HISTORIC AND DESIGN REVIEW COMMISSION

August 01, 2018

HDRC CASE NO:	**2018-367**
ADDRESS:	9599 BRAUN RD
LEGAL DESCRIPTION:	NCB 18230 BLK LOT 25 (BRAUNS FARM COMMERCIAL) & NCB 15664 BLK LOT P-2B
ZONING:	C-1,HE
CITY COUNCIL DIST.:	7
LANDMARK:	Grenwelge / Braun Farm Complex
APPLICANT:	Ginger Johnson
OWNER:	Immersion Outfitters Ministries
TYPE OF WORK:	Construction of a rear and side addition, exterior modifications
APPLICATION RECEIVED:	July 13, 2018
60-DAY REVIEW:	September 11, 2018

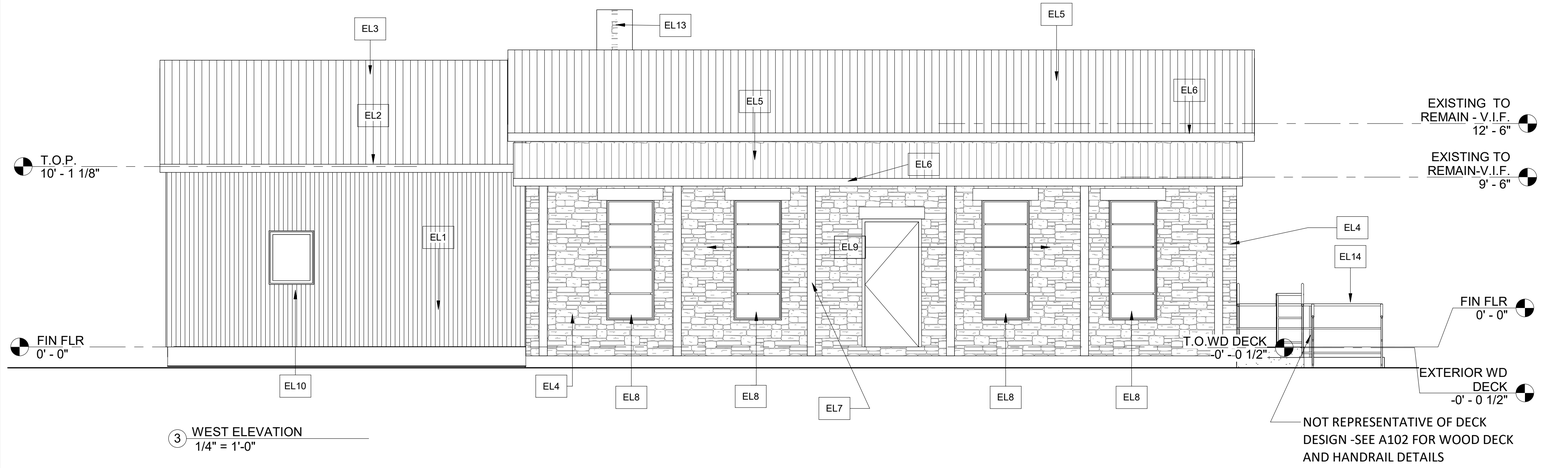
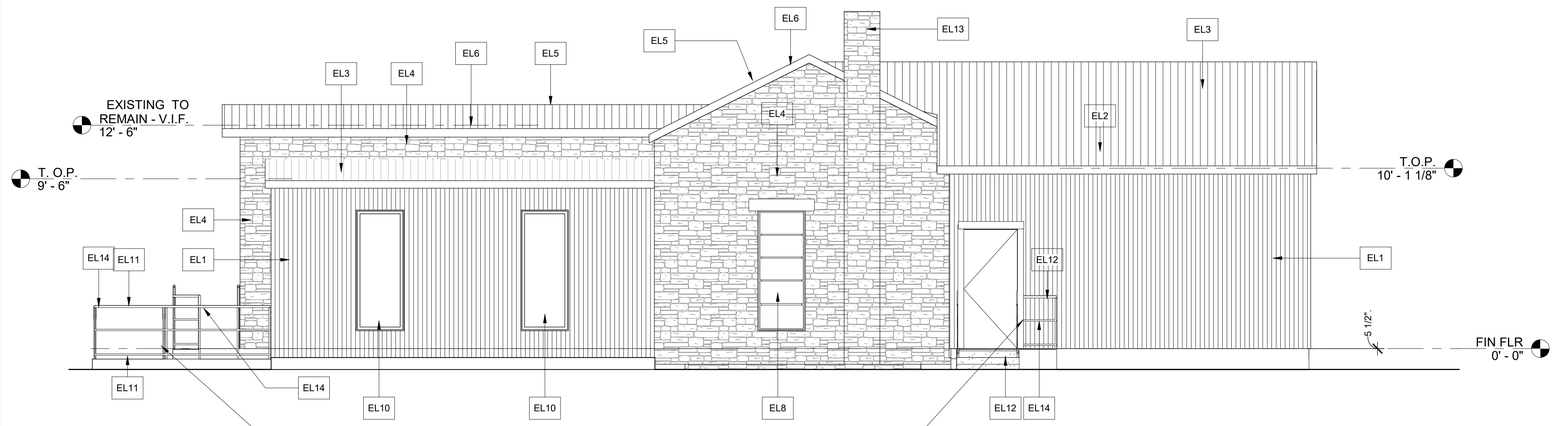
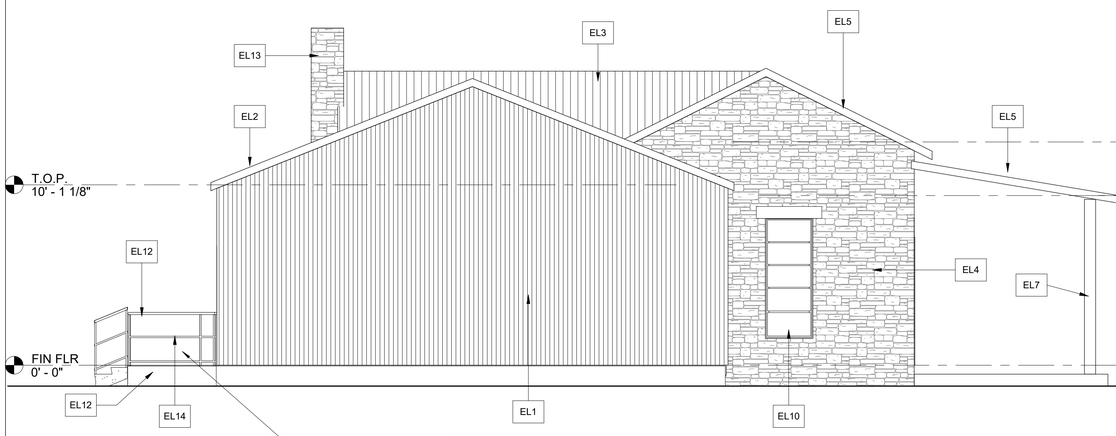
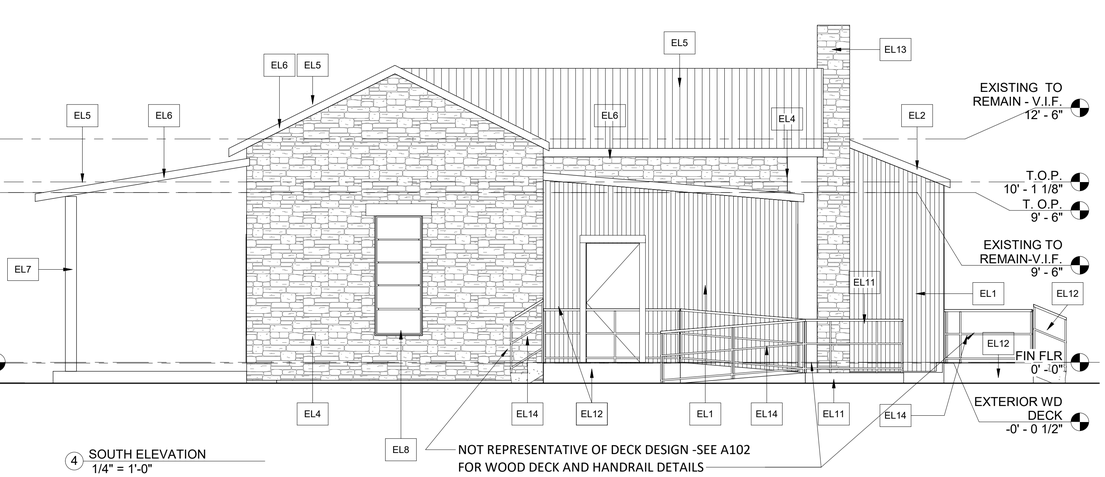
c. NEW ADDITIONS: MASSING AND FOOTPRINT – The applicant has proposed to construct two additions in the same general location of the previous non-contributing additions. The side addition will total approximately 560 square feet, which is slightly larger than the previous side addition, and will be set back from the front façade of the limestone structure by approximately 10 feet. The rear addition will occupy the same space as the previous non-original rear enclosed porch and will utilize the concrete pad. The side addition will feature a slightly lower height than the primary limestone structure and the rear addition will tie into the existing standing seam metal roof. While staff finds the general massing and location of the rear addition to be appropriate, staff finds that the side addition obscures a significant amount of the side elevation of the historic limestone structure. According to the Historic Design Guidelines, additions should be located to the rear whenever possible. There is ample space behind the structure to construct an addition. Staff finds that the proposed side addition should be relocated to the rear of the historic building to be more consistent with the Historic Design Guidelines.

d. NEW ADDITIONS: ROOF – The new side addition will feature a side gable roof with a pitch that matches the side gable of the limestone structure. The rear addition will feature a simple shed roof, similar to the previous non-original porch. The roofing will be standing seam metal to tie into the existing limestone structure's roof. Staff finds the general design approach for the roof configurations, as well as the material, to be appropriate, but finds that the side addition should be relocated to the rear as noted in finding c.

e. NEW ADDITIONS: WINDOWS AND DOORS – The applicant has proposed to install several window and door openings on the new additions. Several windows and doors will match the opening sizes and proportions of those on the existing limestone structure, which are consistent with the Guidelines. However, the proposed elevations indicate that the windows will not be divided and will contain a single pane of glass, which is inconsistent with the Guidelines. Additionally, one window on the front elevation of the side addition will feature a square proportion. Staff finds this square proportion to be inconsistent. The north elevation of the side addition also does not feature any window openings. As noted in findings c and d, the side addition should be relocated. The applicant should install openings on every elevation that feature profiles and configurations that are consistent with the Guidelines.

f. NEW ADDITIONS: FAÇADE MATERIAL – The applicant has proposed to install new vertical cedar siding on the additions. The siding features a profile of a few inches and will not feature battens. According to the Historic Design Guidelines, materials that match in type, color, and texture and include an offset or reveal to distinguish the addition from the historic structure should be used whenever possible. Any new materials introduced to the site as a result of an addition must be compatible with the architectural style and materials of the original structure. Staff does not find vertical cedar siding appropriate without the use of battens.

Items 2 and 3, Staff does not recommend approval of the proposed side and rear additions at this time based on findings c through f. Staff recommends that the applicant make the following modifications prior to resubmitting to the HDRC:

i. That the applicant relocates the proposed side addition to the rear of the historic structure as noted in finding c.
ii. That the additions feature true board and batten siding with boards that are twelve (12) inches wide with battens that are 1 – ½" wide.
iii. That the applicant installs fenestration featuring appropriate proportions and configurations on all elevations of the additions as noted in finding e.
iv. That the windows feature a one over one configuration and meet the following stipulations: Meeting rails must be no taller than 1.25" and stiles no wider than 2.25". There should be a minimum of two inches in depth between the front face of the window trim and the front face of the top window sash. This must be accomplished by recessing the window sufficiently within the opening or with the installation of additional window trim to add thickness. Window trim must feature traditional dimensions and architecturally appropriate sill detail. Window track components must be painted to match the window trim or concealed by a wood window screen set within the opening.

v. That the standing seam metal roof features panels that are 18 to 21 inches wide, seams that are 1 to 2 inches tall, a crimped ridge seam and a standard galvalume finish.
